CALIFORNIA COASTAL COMMISSION

TO: Commissioners and Interested Persons **W 4a**

SUBJECT: Revised Findings
City of Dana Point Local Coastal Program Amendment 1-03
Dana Point Headlands

Dana Point LCP Amendment 1-03
Revised Findings

FIGURE 4.16.1

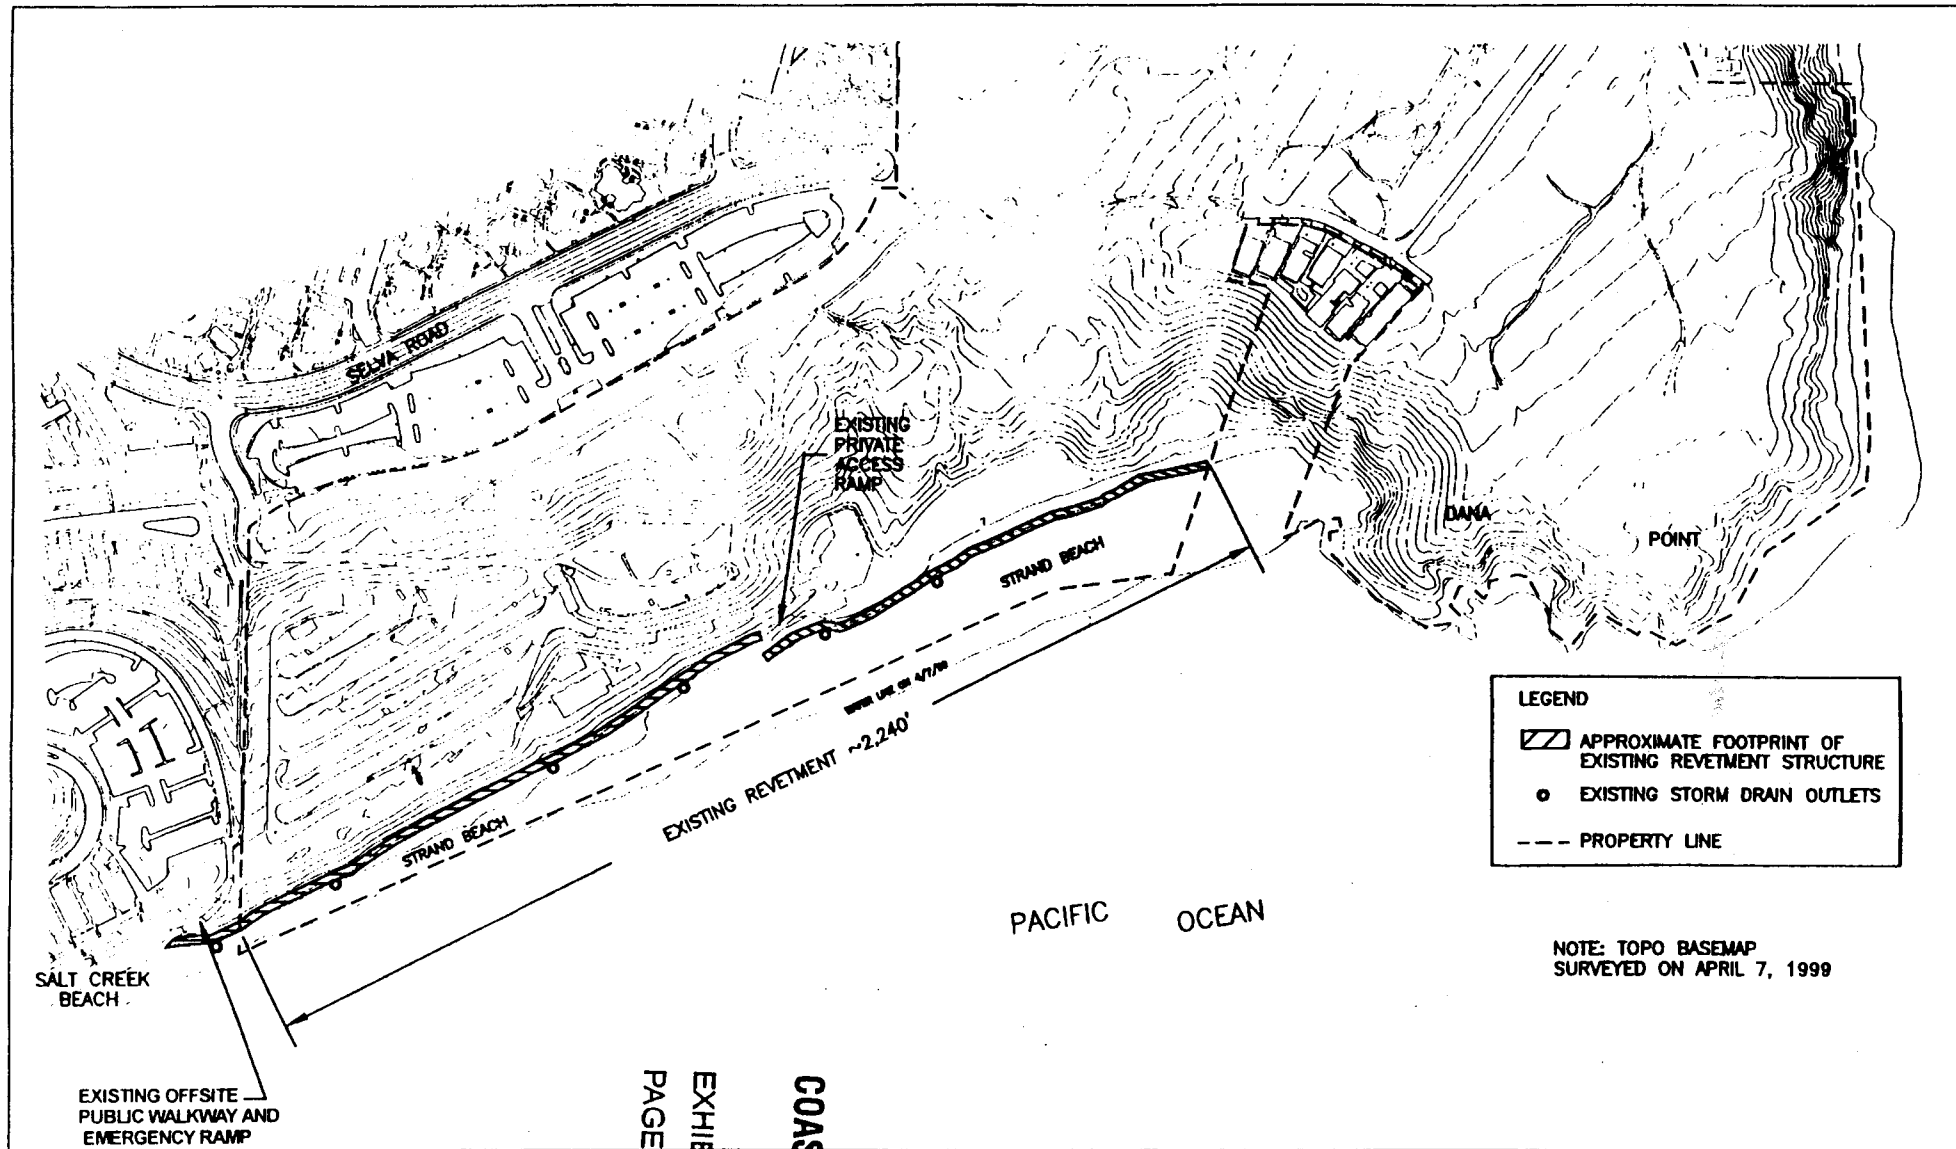
191. (Biology/Water Quality/Hazards) Figure 4.16.1 Landscape Zone Master Plan, Modify Figure To Revised Development Plan; Revise Locations Of 'Native And/Or Indigenous' To Incorporate All Portions Of The Headlands, Excepting The Individual Residential Lots and Planning Area 9; Revise The 'Drought Tolerant' Designation To Read 'Drought Tolerant, Non-Invasive' And Apply That Designation To The Residential Lots and Planning Area 9

FIGURE 4.11.1

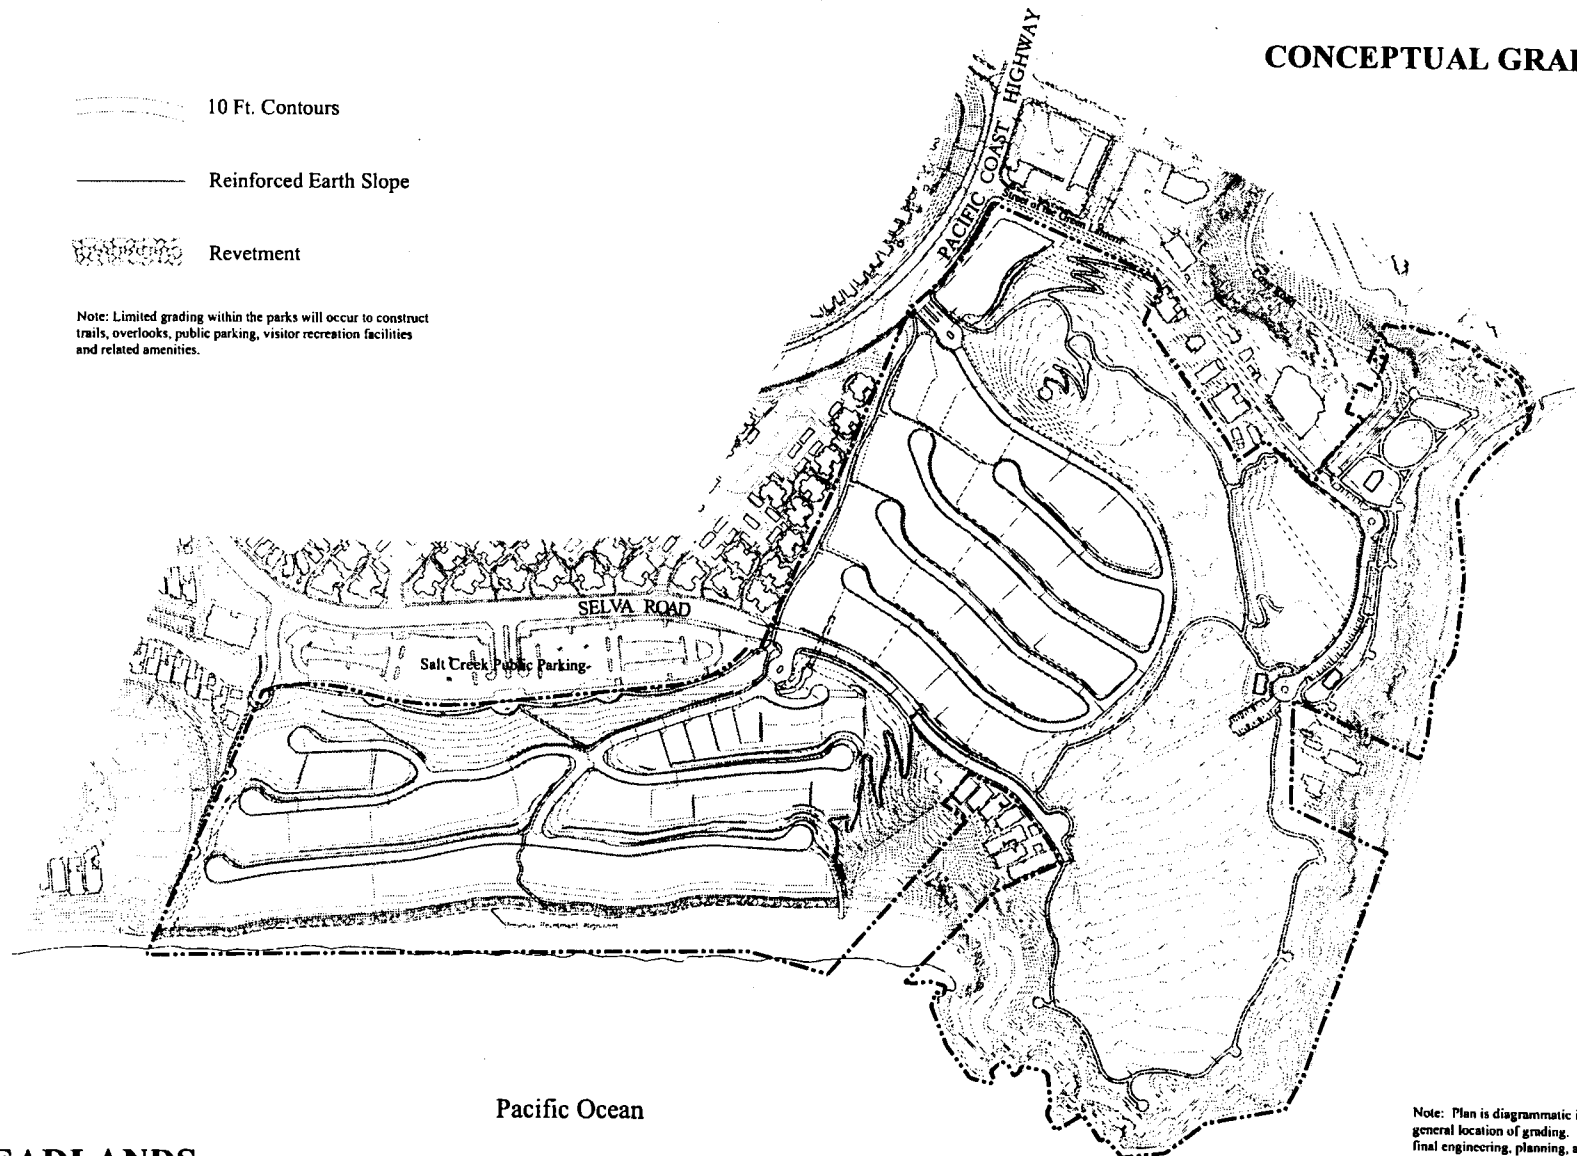
185. (Biology/Hazards/Views) Figure 4.11.1 Conceptual Grading Plan: Revise Grading Plan To Reflect Reconfiguration Of Bowl Area Residential To Avoid Esha (Except For Allowable Impact Area Identified In The General Plan/Lue/Ude/Cose); And Revise Grading Plan In Strand Residential To Reflect More Landward Alignment Of Shoreline Protective Device.

FIGURE 1
EXISTING REVETMENT ALIGNMENT (TOE)
JANUARY 8, 2004

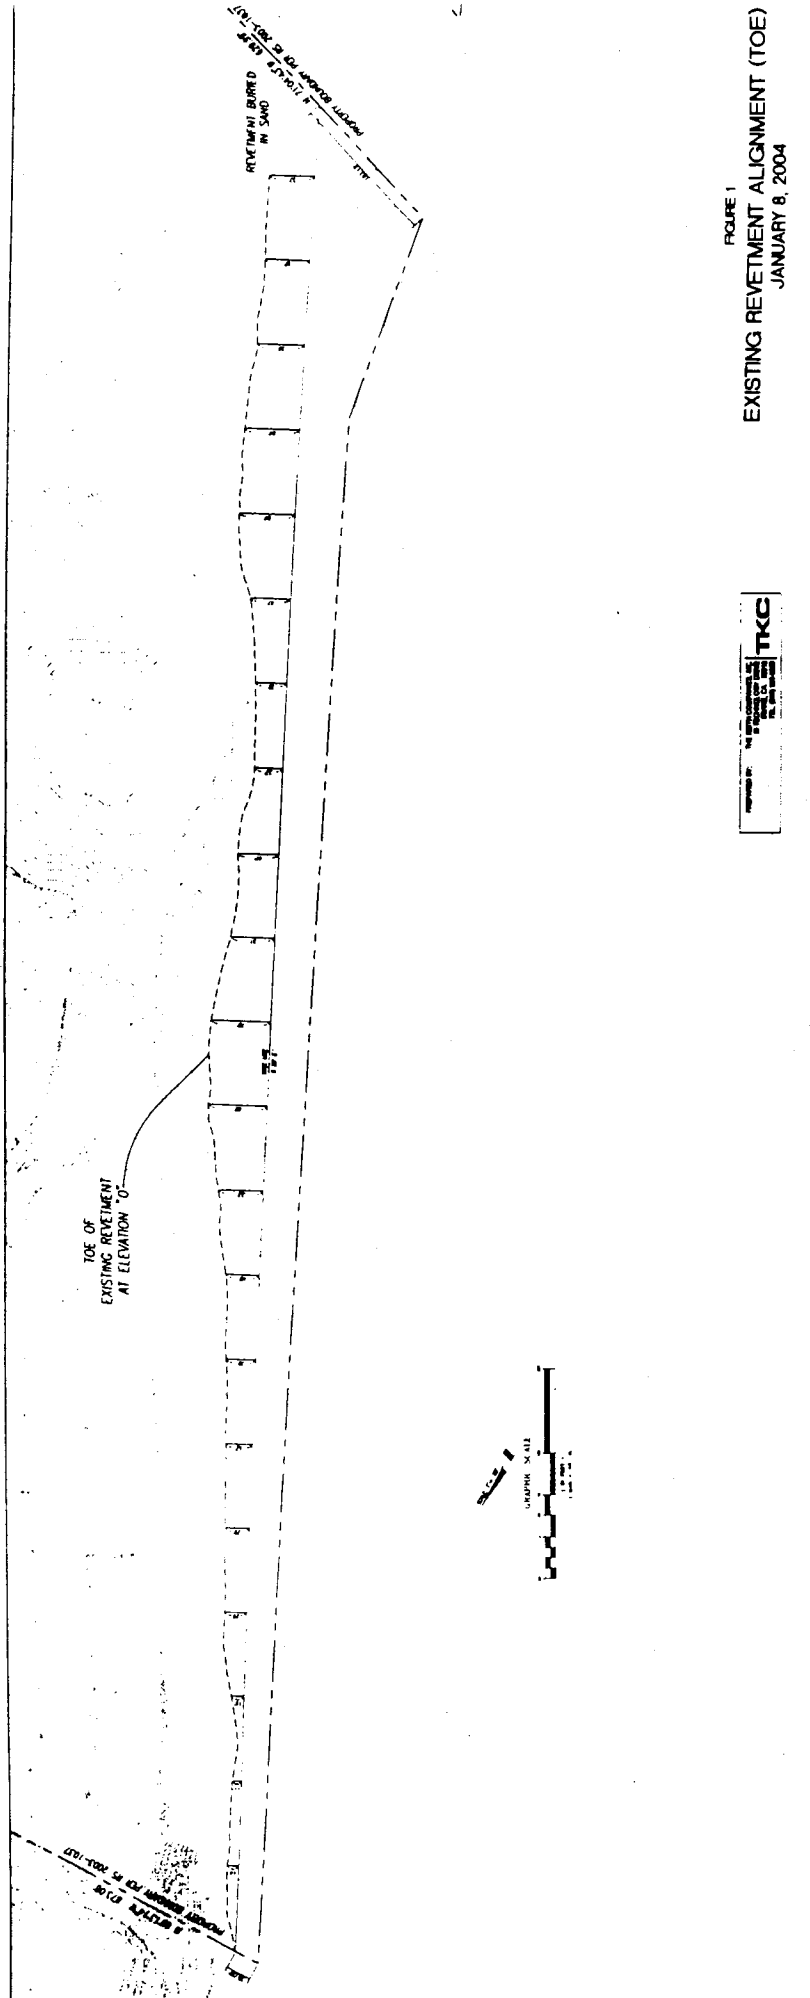
The shoreline protective device shall be located at or landward of the existing revetment toe (depicted on Figure 1, Existing Revetment Alignment (TOE), The Keith Companies dated January 8, 2004), such that, the average position of the shoreline protective device is moved at least 5 feet landward or easterly.
